**Subject: Alameda Car Wash Traffic Impact Study  
NM 528 (MP 0.25 to 2) between 4<sup>th</sup> Street and 2<sup>nd</sup> Street  
Albuquerque, Bernalillo County, New Mexico**

This letter is to inform you that the **FINAL** Traffic Impact Study (TIS) for the proposed Alameda Car Wash on the north side of NM 528 between 4<sup>th</sup> Street and 2<sup>nd</sup> Street dated January 16, 2019 has been reviewed.

# EXHIBIT A

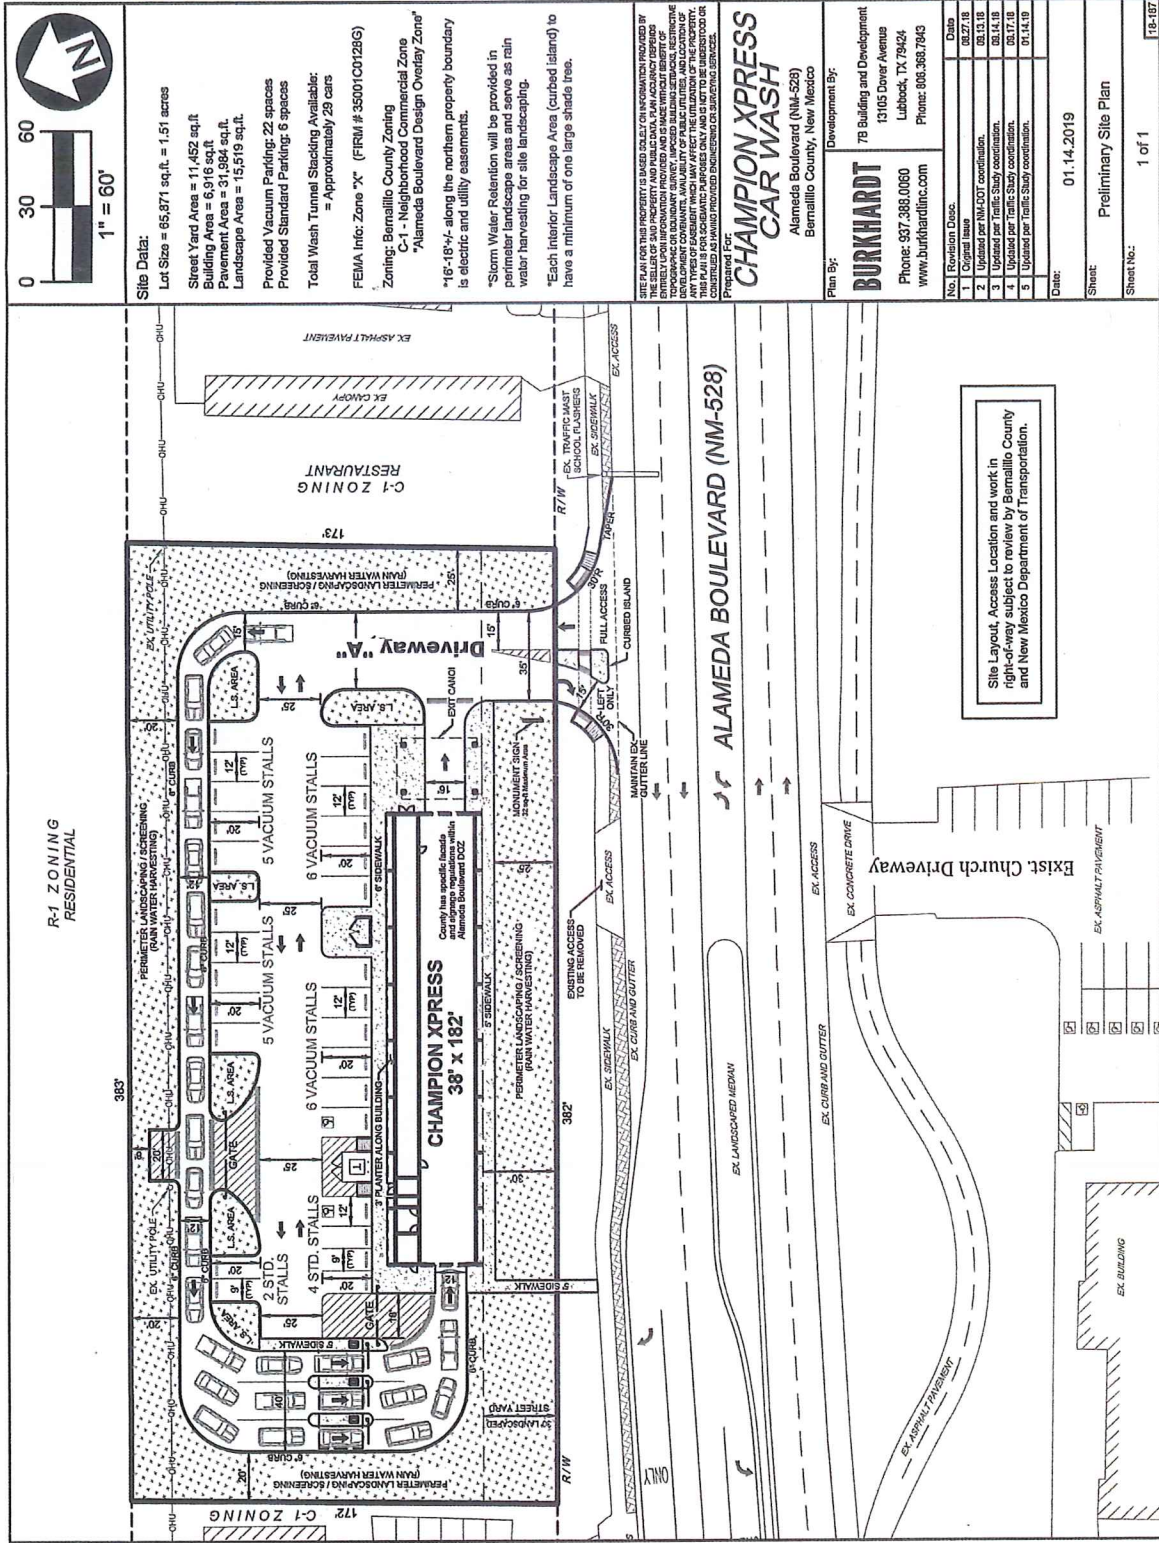
The NMDOT has no objection to the (1) partial Right-In/Out, Left-In access on NM 528 located approximately 500 feet east of the signalized intersection of NM 528 and 4<sup>th</sup> Street. See Exhibit A for the conceptual site plan.

1. NMDOT concurs with the site plan that maximizes on-site queuing by positioning the building closest to NM 528.
2. The Property Owner shall submit a Commercial Driveway Application for Driveway "A". Access shall be located on the most eastern side of the property.
3. The development shall build a westbound deceleration lane/taper for as long as possible at Driveway "A".
4. The development shall modify the existing inside median curb and gutter and landscaping on NM 528 at 4<sup>th</sup> Street to maximize the potential need for the westbound left turn lane.
5. The development shall remove the existing driveway and replace the sidewalk, curb and gutter in kind.
6. The development shall reconstruct any existing damaged sidewalk along its frontage of NM 528.
